Detailed Site Plan Branchville Crossing

DET-2025-010

REQUEST	STAFF RECOMMENDATION
Development of an 87-unit apartment building for elderly or physically disabled families, with associated infrastructure and amenities.	With the conditions recommended herein: • APPROVAL of Detailed Site Plan DET-2025-010 • APPROVAL of Type 2 Tree Conservation Plan TCP2-2026-0005

SUBJECT: Detailed Site Plan DET-2025-010
Type 2 Tree Conservation Plan TCP2-2026-0005
Branchville Crossing

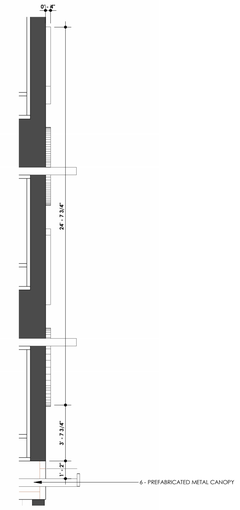
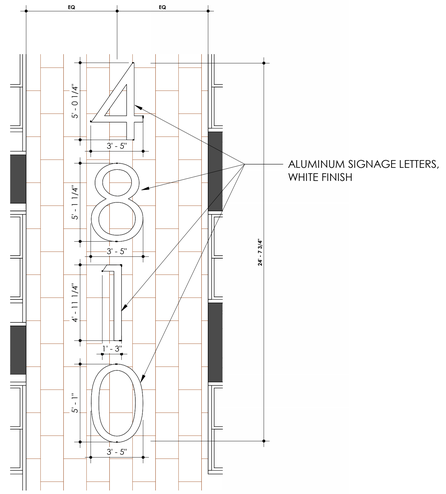
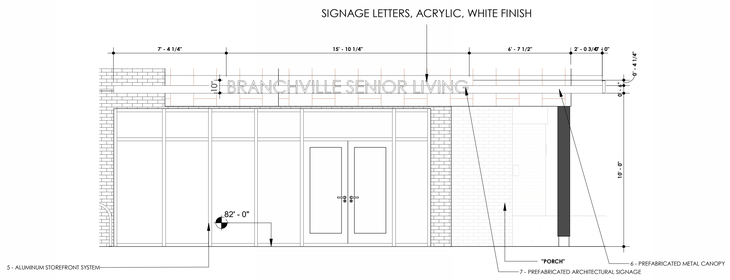
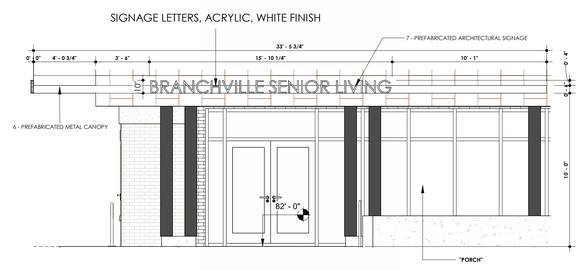
The subject DET includes three canopy signs. Although these signs are located approximately 180 feet from the lot line shared with single-family detached dwellings in a single-family residential zone, they are not permitted in accordance with Section 27-61505, and are conditioned herein to be removed from Sheet A-0008. No project signs are included in this DET.

The subject DET includes four signs, of which three are canopy signs and one is a wall-mounted sign. Pursuant to Section 27-61502(b)(2), the proposed wall-mounted sign is exempt from the sign standards because it displays the street address of the proposed development. A condition is included herein requiring the applicant to remove any information regarding the building wall or roof signs from Sheet A-0008 and note on this sheet that "4810" is an address sign. As discussed in Finding II.D above, the use proposed with this development is a residential use but is not considered as the "multifamily" use. Canopy signs are not permitted because Section 27-61505 notes, "No requirement for residential use, except multifamily." A condition is included herein requiring the applicant to remove the three proposed canopy signs from Sheet A-0008.

(1) Remove any building wall or roof sign information from Sheet A-0008 and note on this sheet that "4810" is an address sign.

(2) Remove any information regarding the three proposed canopy signs from Sheet A-0008.

6-FOOT HIGH WOOD SCREEN FENCE
NTS

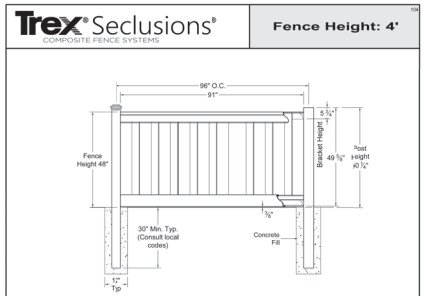
- **The Applicant shall submit a Phase II Noise Study to the City and M-NCPPC. Based on the study results, the Applicant shall modify the 6-foot wood screen fence detail on Drawing 6.005-Z to incorporate noise-mitigating materials (such as a solid-core or "Plywall" system) to ensure interior noise levels do not exceed 45 dBA and outdoor activity areas do not exceed 65 dBA.**

PHOTOMETRIC EVALUATION
NOT FOR CONSTRUCTION

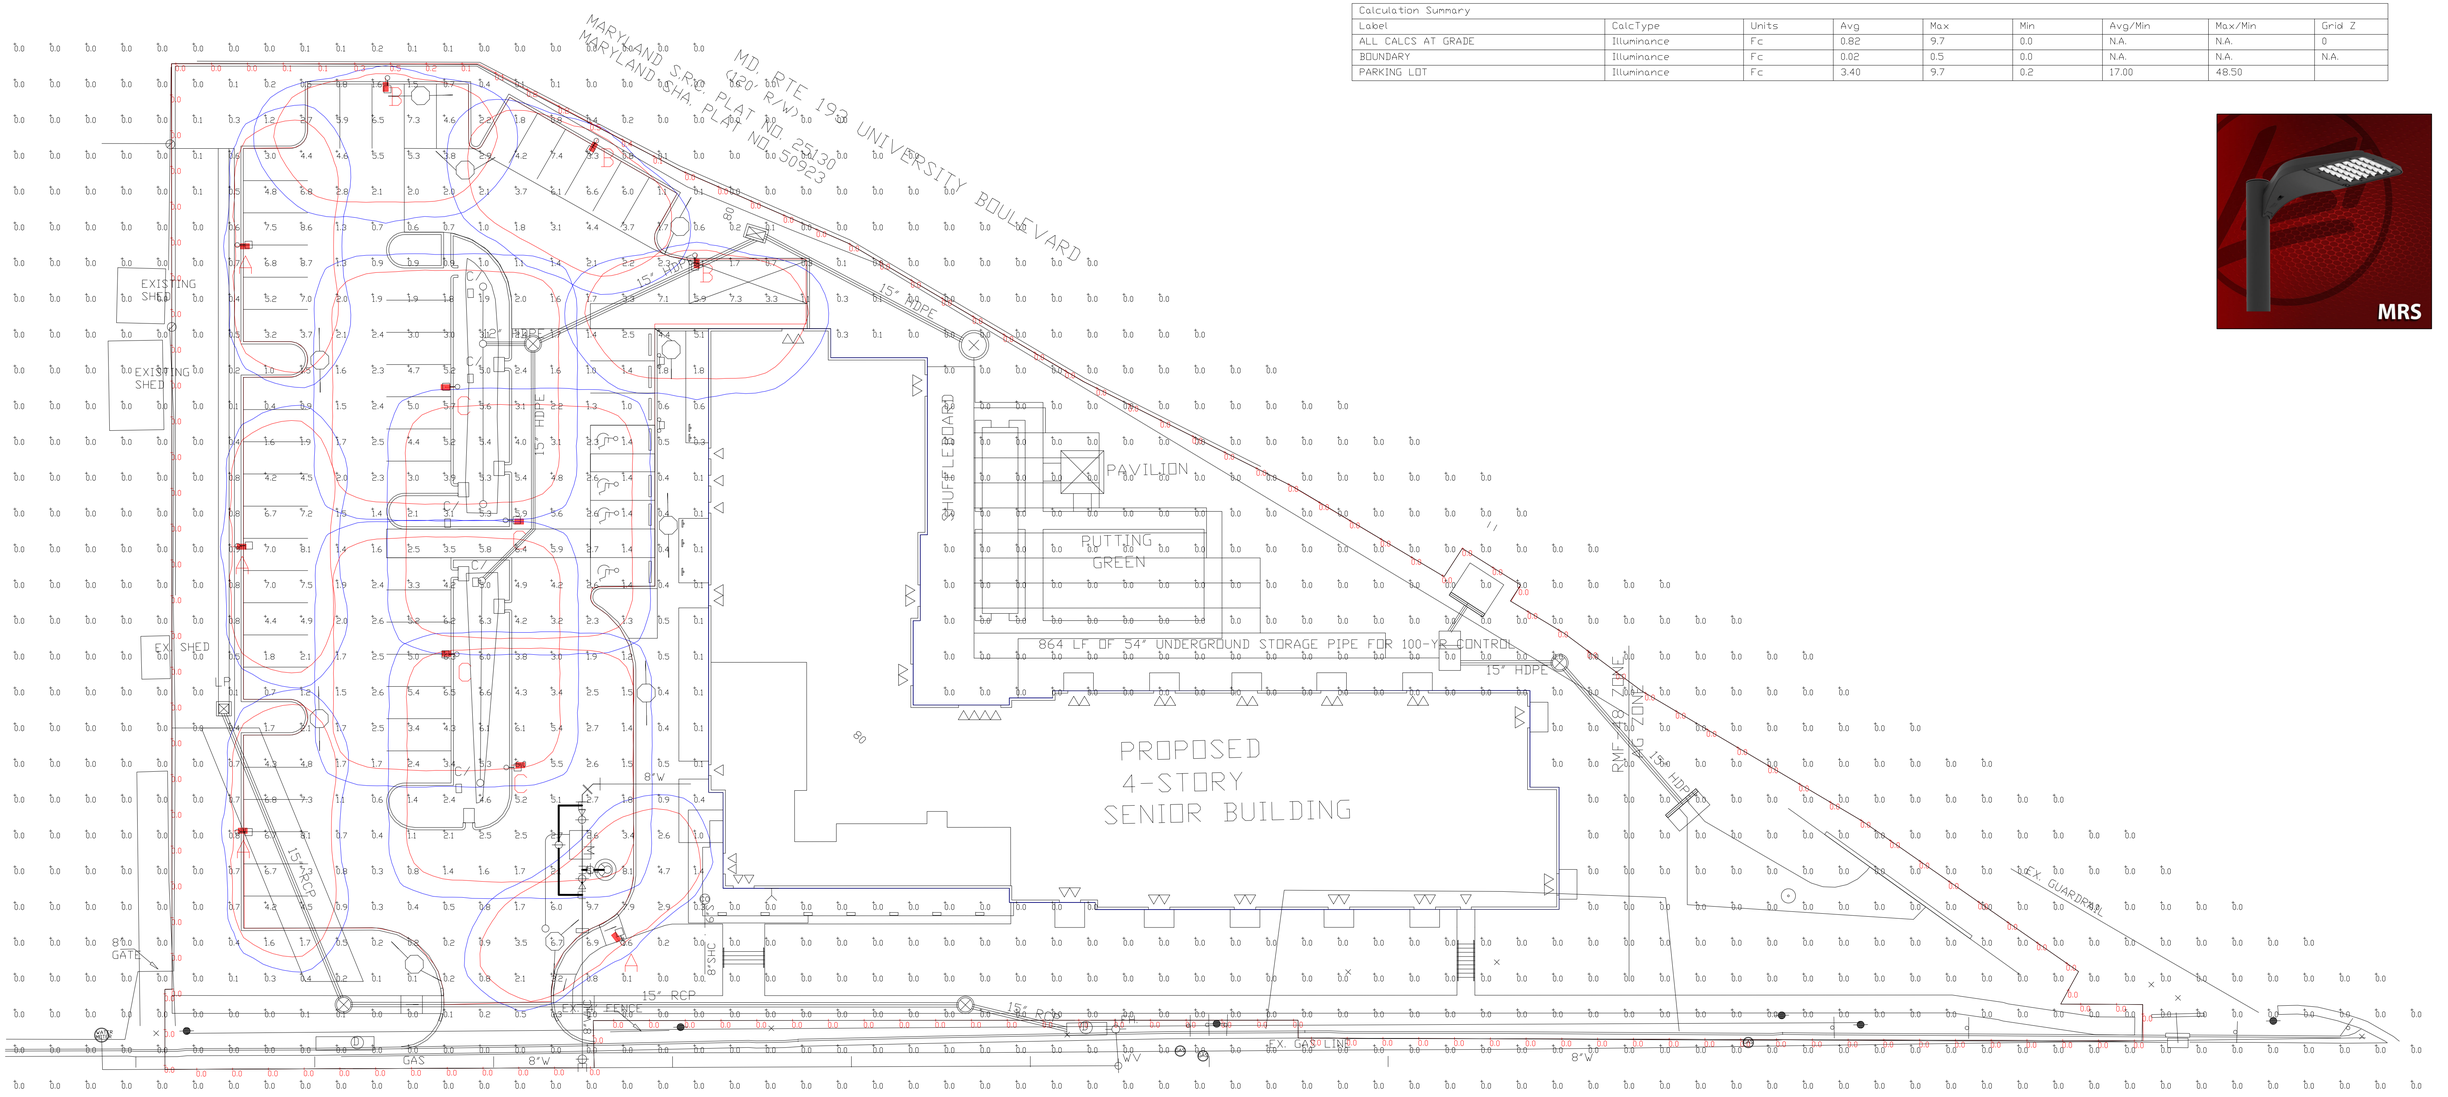
Sheet A-0009 includes several specific exterior lightings, including canopies, sconce lights, pedestrian lighting, decorative landscaping and lighting, with details. However, some information is missing, such as the required foot-candle levels and the wattage of the fixtures, which is conditioned herein to be provided. The submitted photometric plan demonstrates that the internal driveway and walkways within the parking area are adequately lit. However, it does not show the lighting conditions for the walkways within the amenity area. A condition is included herein requiring the applicant to revise the photometric plan demonstrating conformance to Section 27-6707(e) of the Zoning Ordinance.

i. Add the required foot-candle levels and the wattage of the fixtures to Sheet A-0009.

OUTBOUND TRUCK TURNING

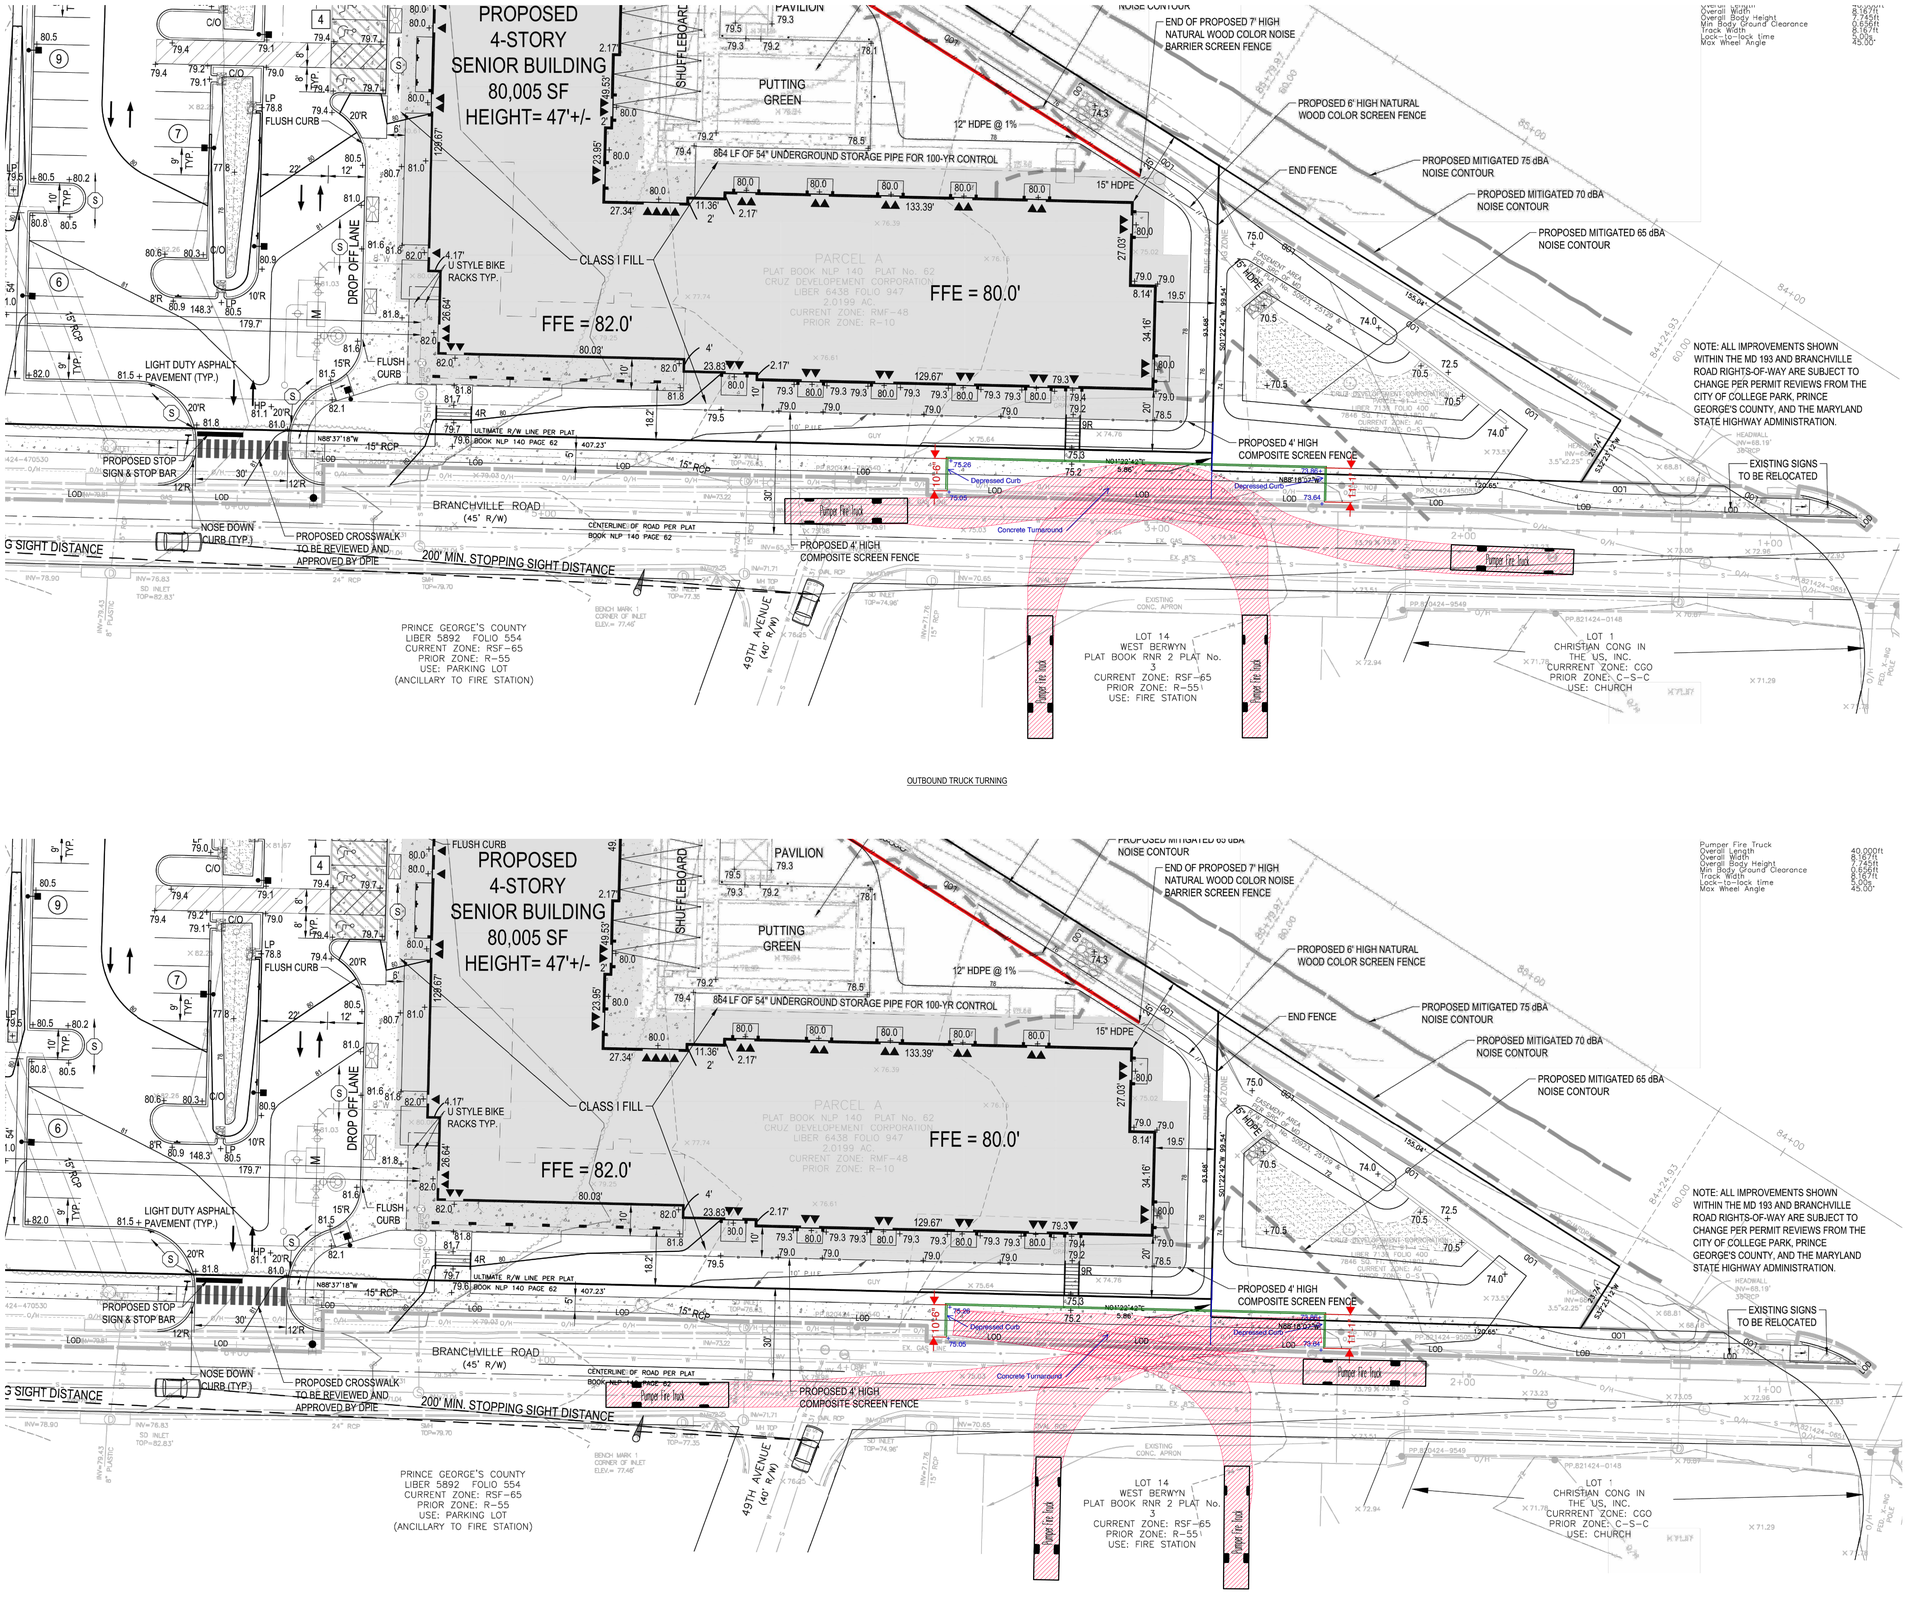
- At 26 feet wide, Branchville Road is barely wide enough for units to exit the station safely.
  - The turn radius of the fire engines already requires fire apparatus to cross over the mountable curb onto the existing run-over area along the North side of Branchville Road.
  - Prince George's County Fire Department provided guidance (Atch 1) for Cruz Development's 1988 DSP application which they incorporated into their 1988 plans (below).

COLLEGE PARK RECOMMENDATION 1

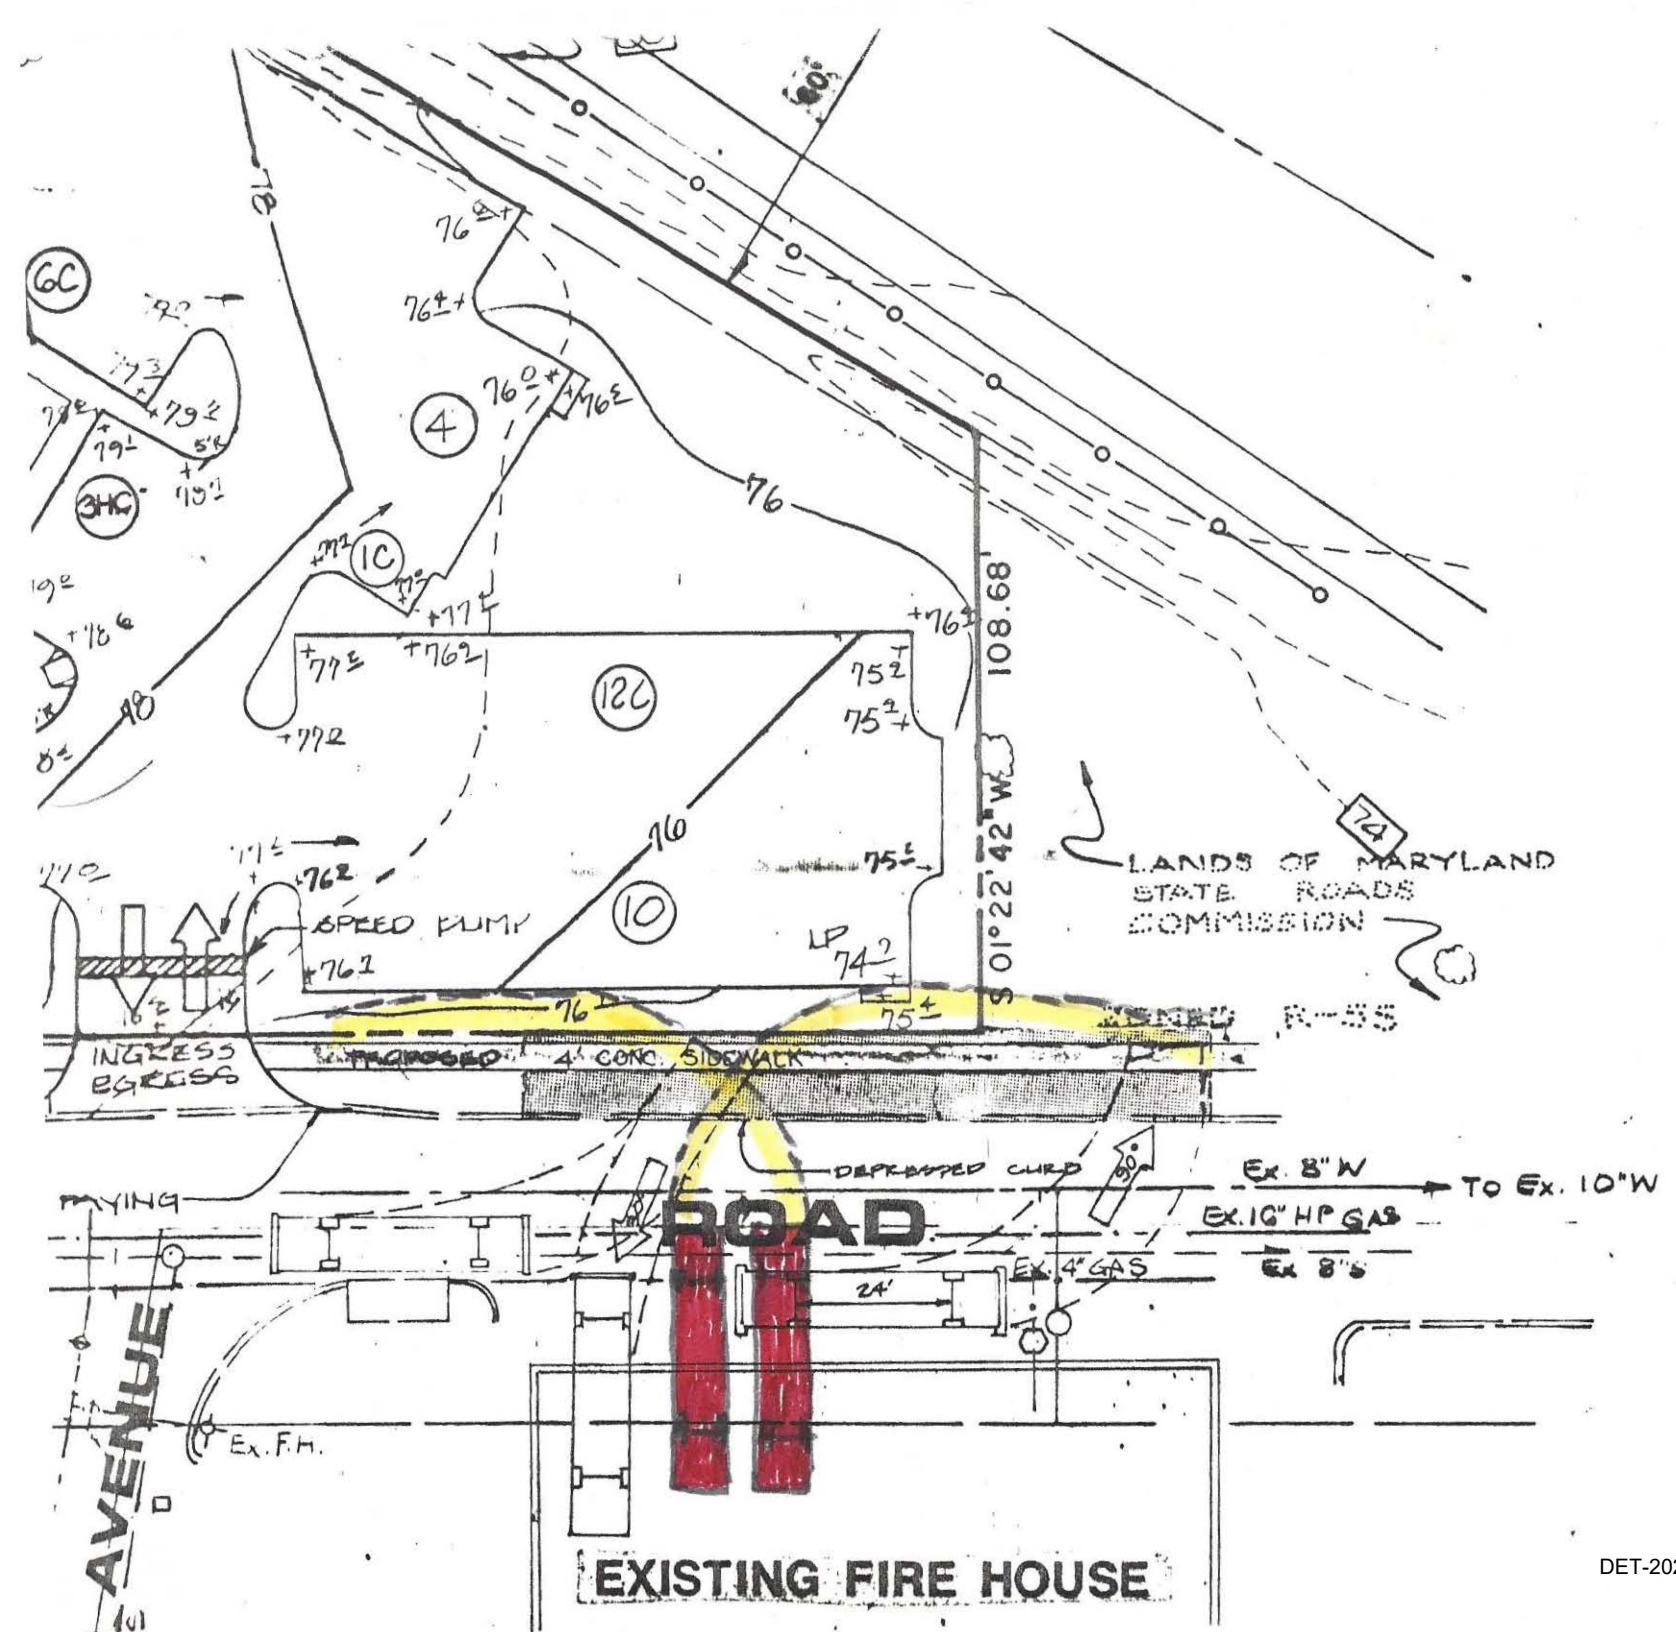
p. Provide sidewalk access from the building to the eastern terminus of Branchville Road, as shown in the City of College Park's Exhibit 3, a crosswalk across Branchville Road, and a public use easement agreement to the City, as needed. Construction plans for the sidewalk in the Branchville Road right-of-way shall be submitted to the City Engineer for review and permitting.
